ADDENDUM 1 – JOB 20

TO: All prospective bidders on project NH-3-281(122)253, Job No. 20 scheduled for the April 8, 2016 bid opening.

Project: NH-3-281(122)253 (PCN-21204)

Revised 3/22/2016	STATE	PROJECT NO.	SECTION NO.	SHEET NO.
	ND	NH-3-281(122)253	20	12

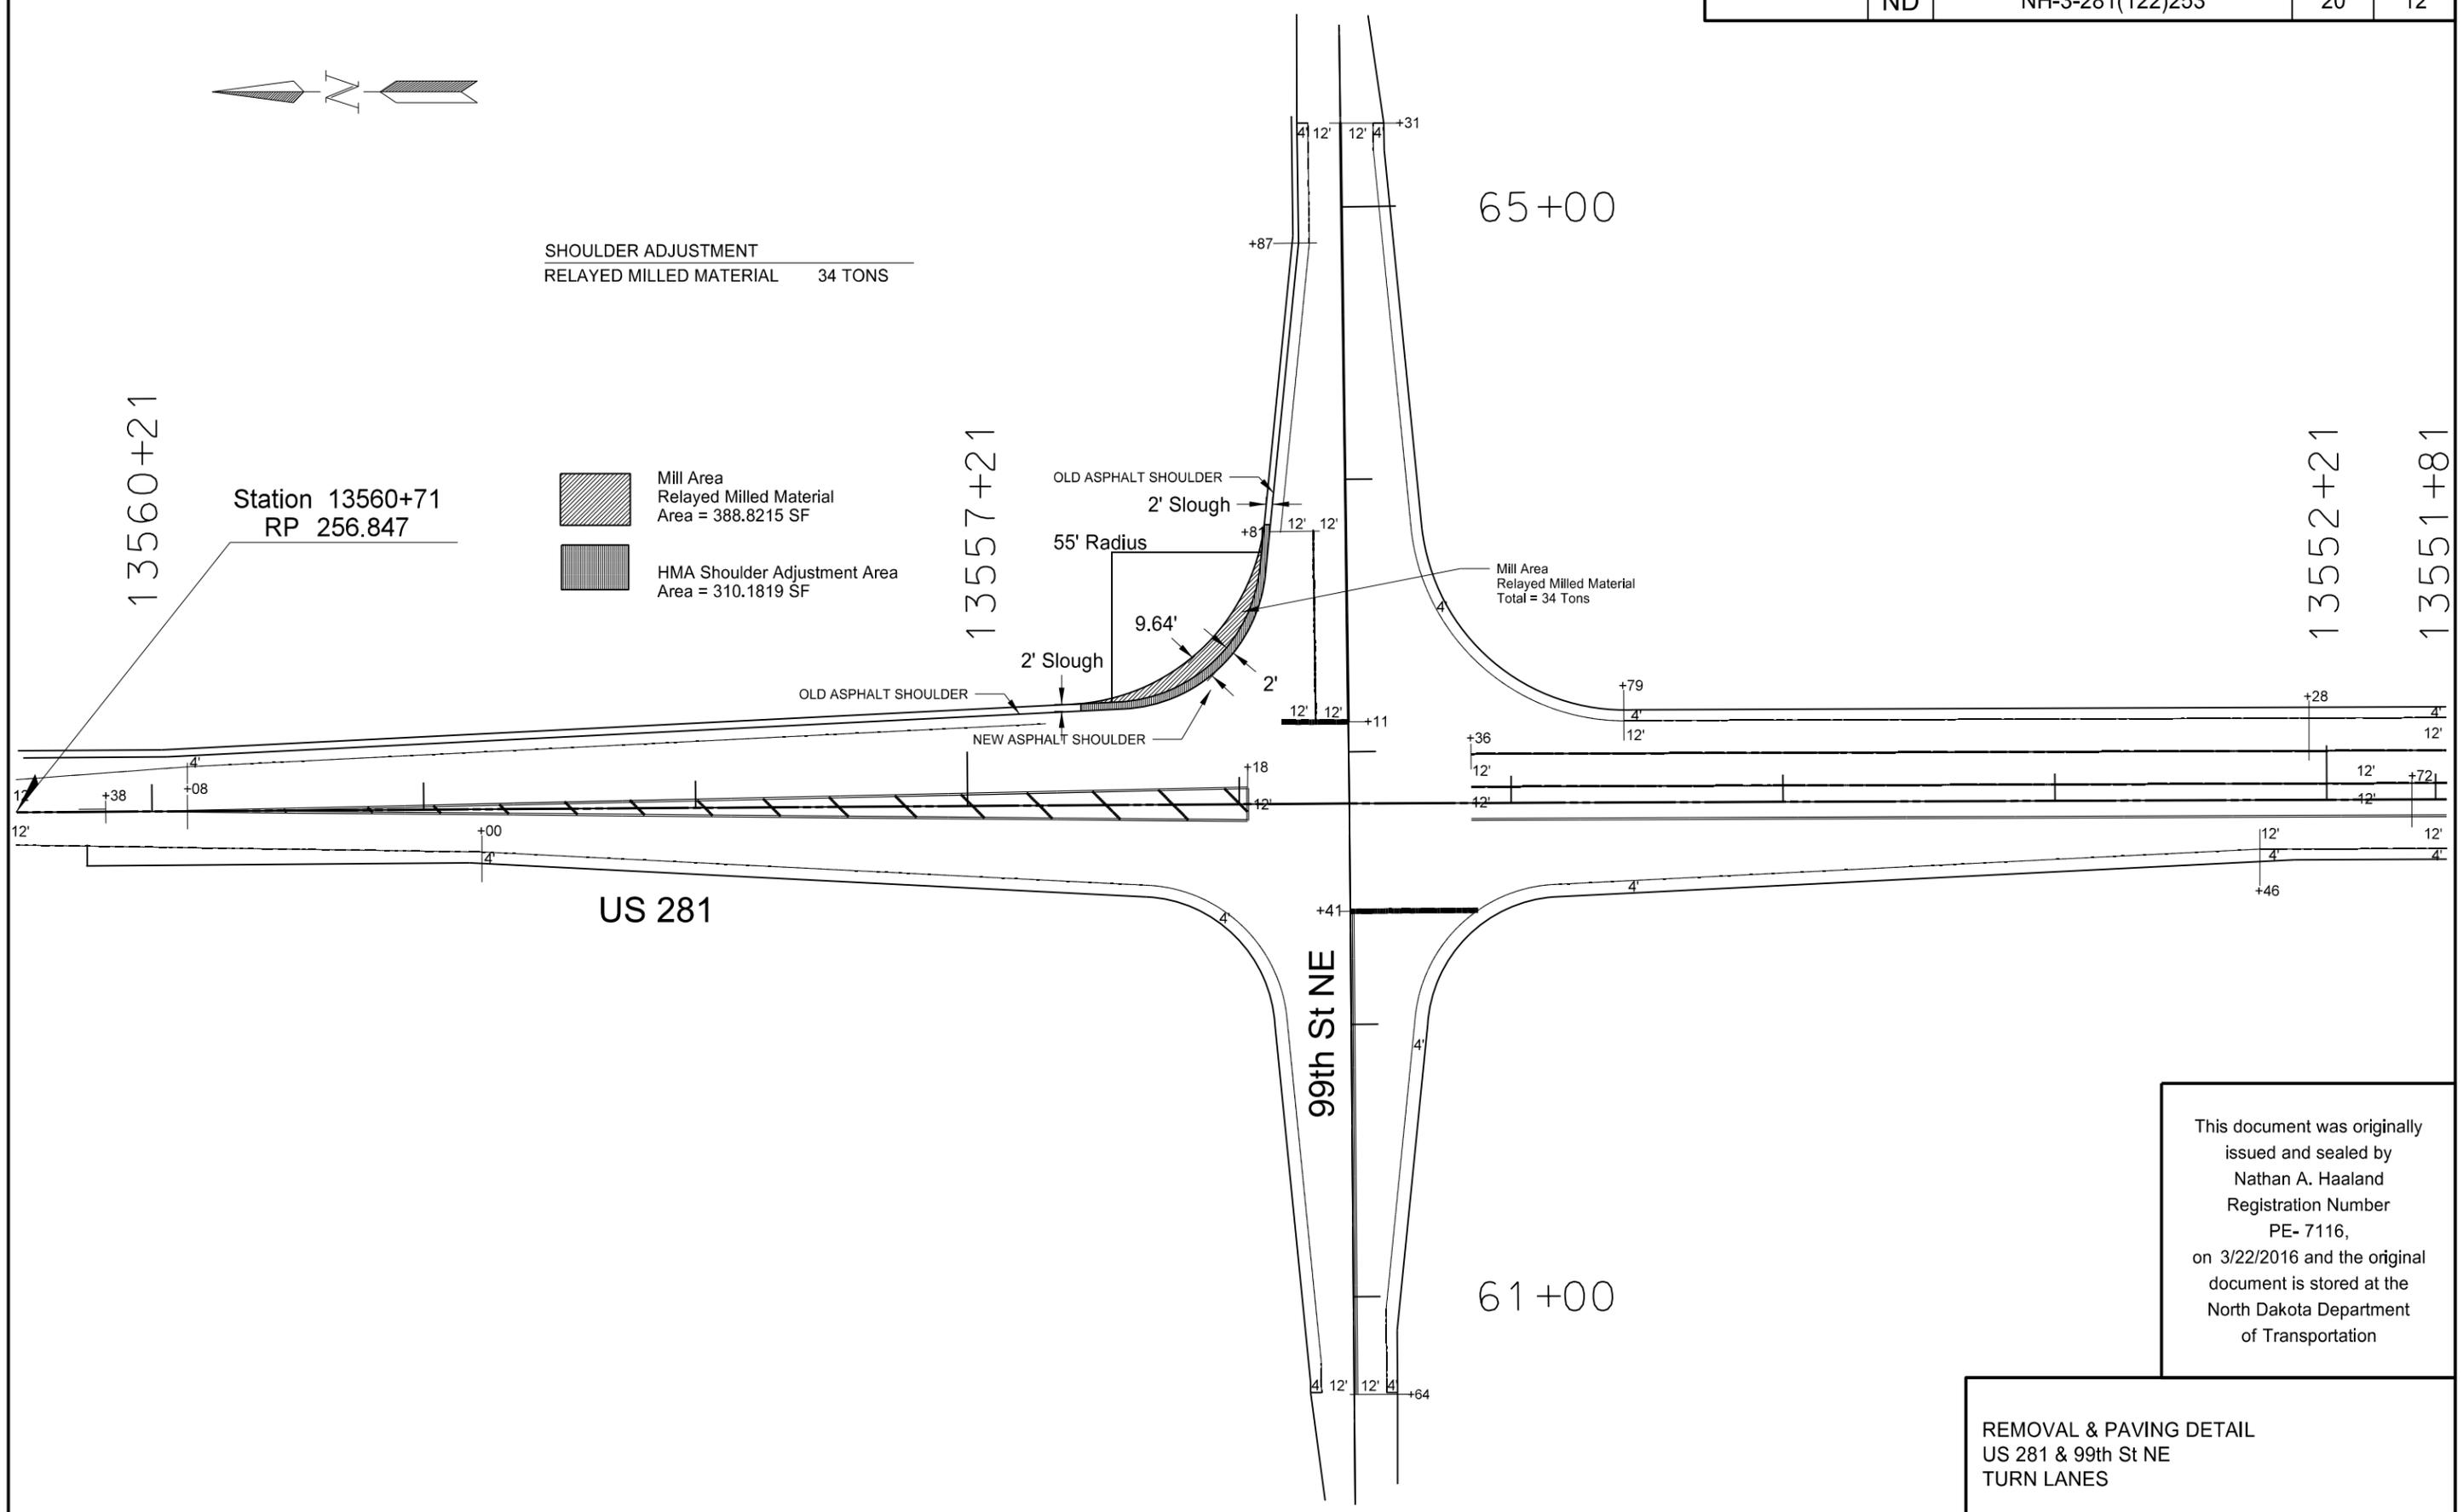
Sheet 20-12:

Sheet added to show shoulder adjustment area at JCT US 281 and 99th St. NE.

SHOULDER ADJUSTMENT
RELAYED MILLED MATERIAL 34 TONS

Mill Area
Relayed Milled Material
Area = 388.8215 SF
 HMA Shoulder Adjustment Area
Area = 310.1819 SF

PAVEMENT MARKING
US 281 & 99th St NE
TURN LANES

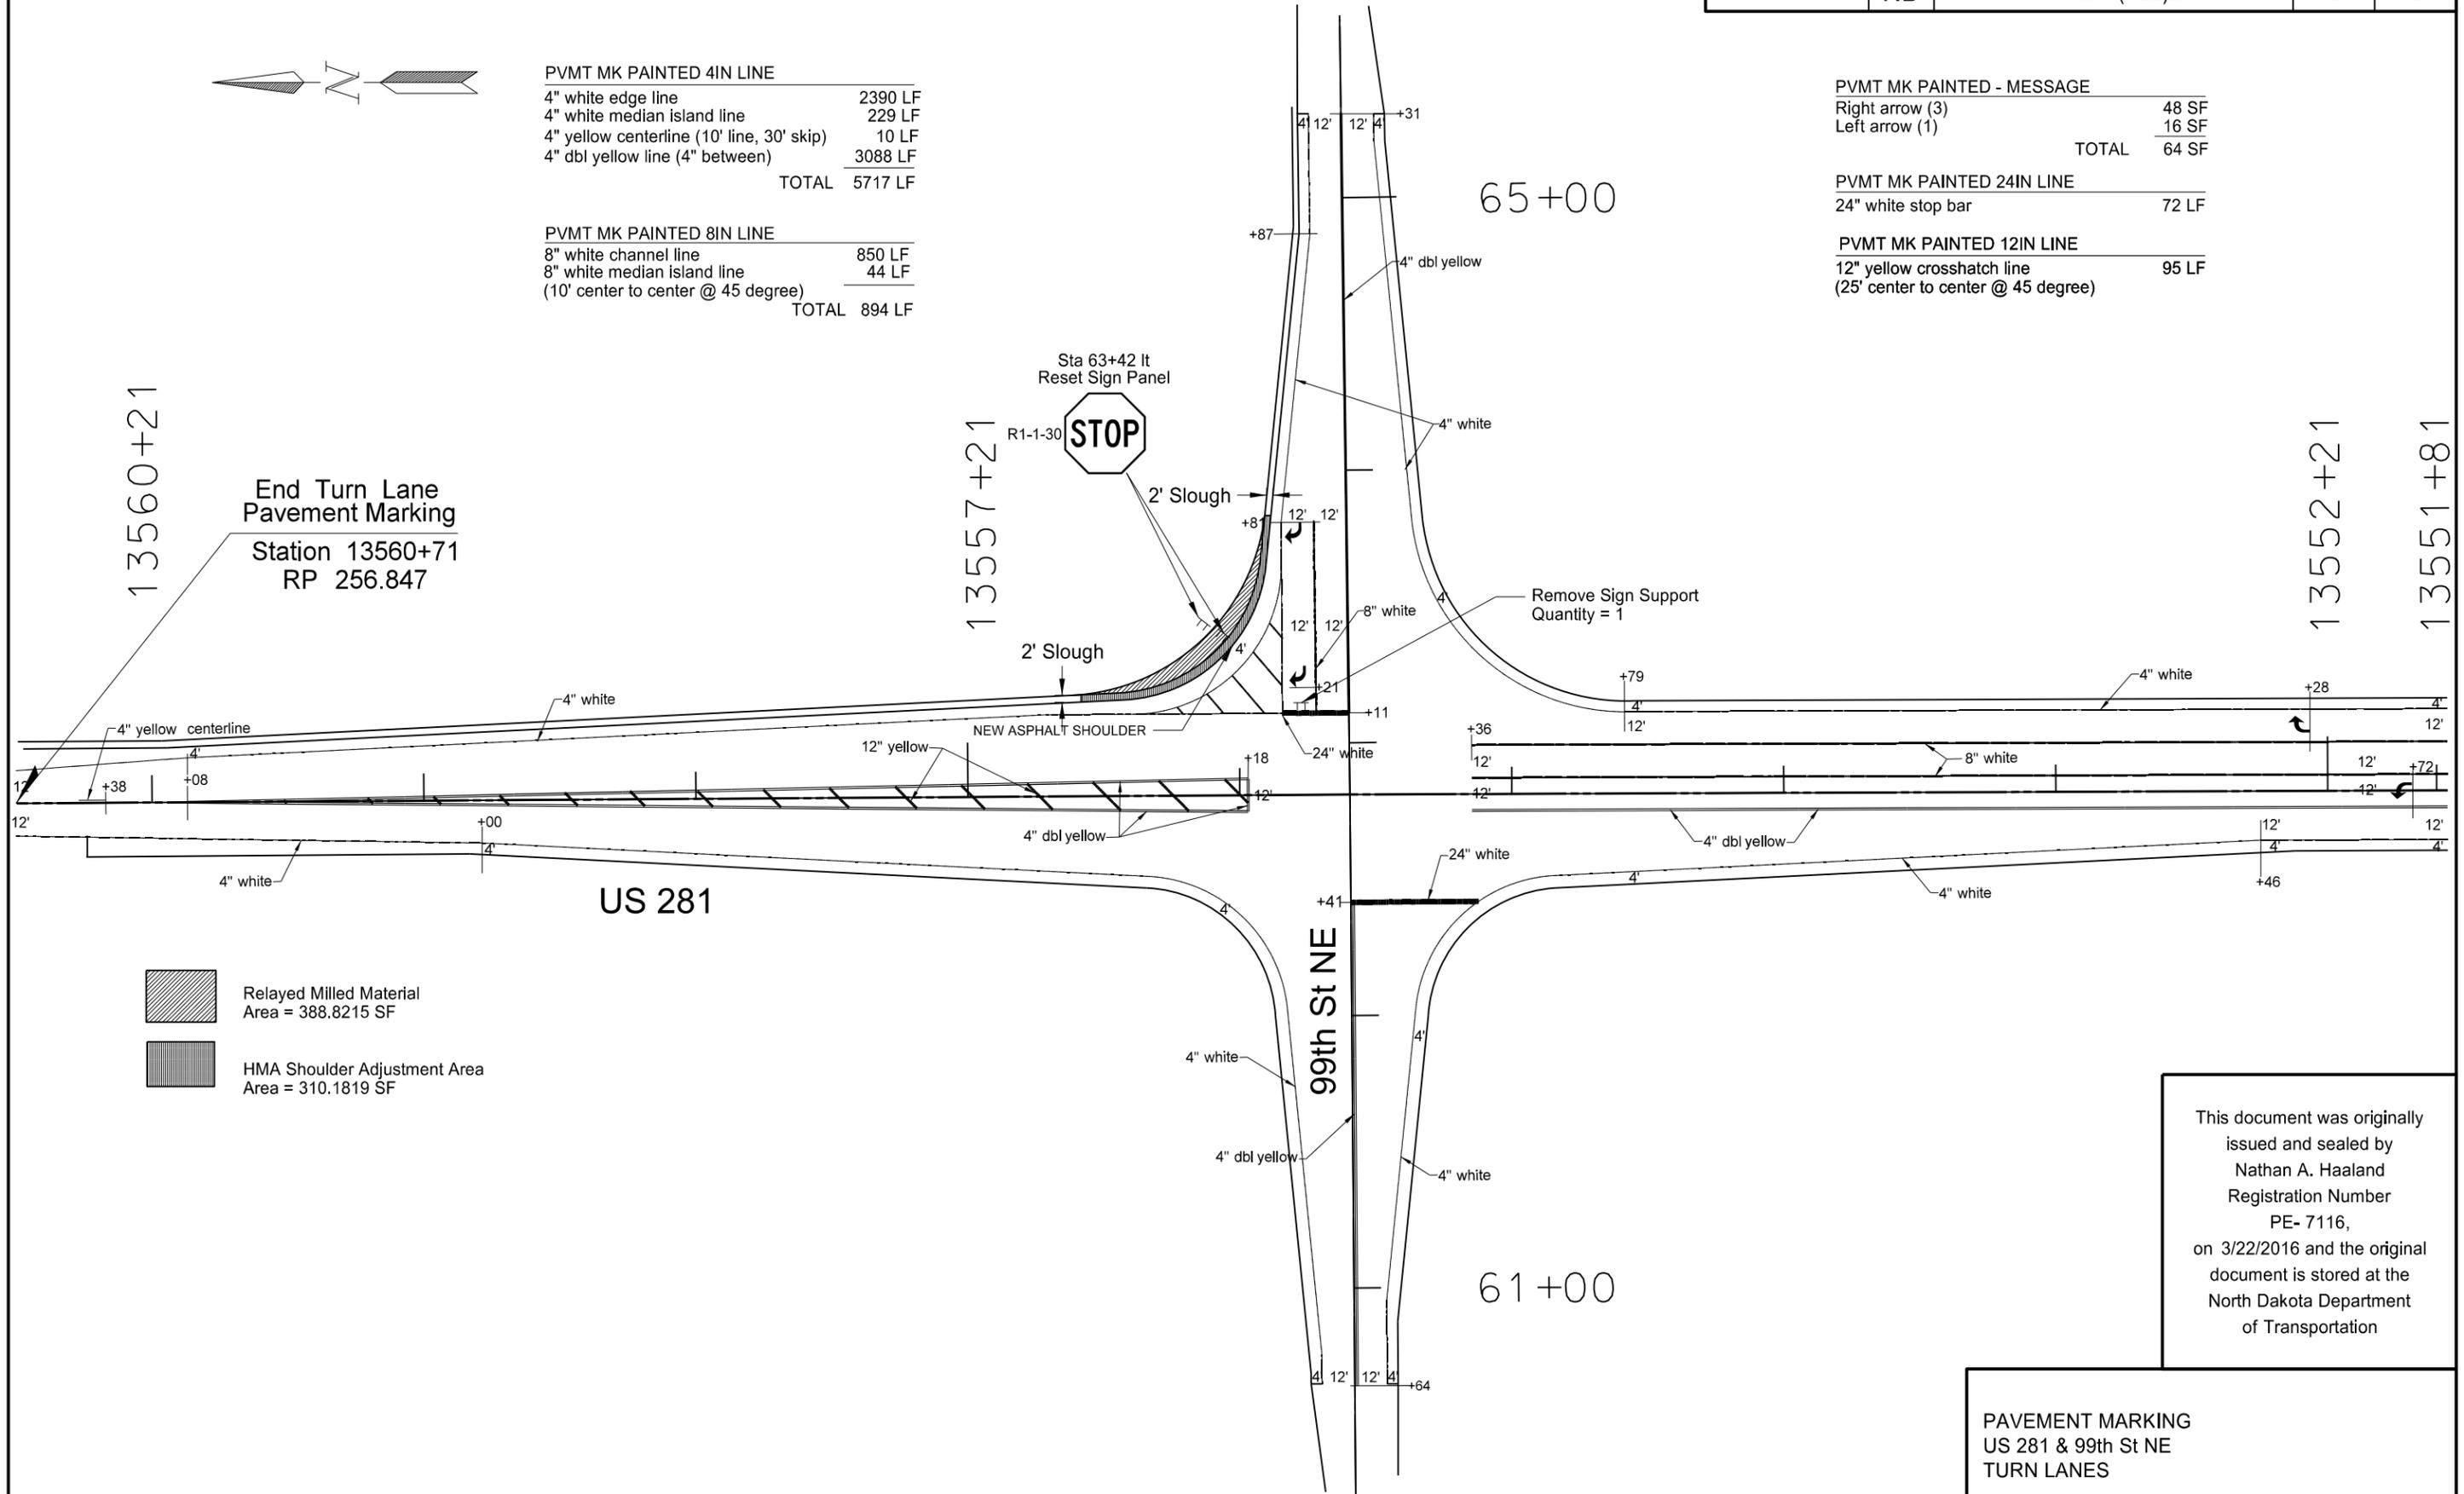
Sheet 120-2:

Sheet has been revised to show RESET SIGN PANEL location.
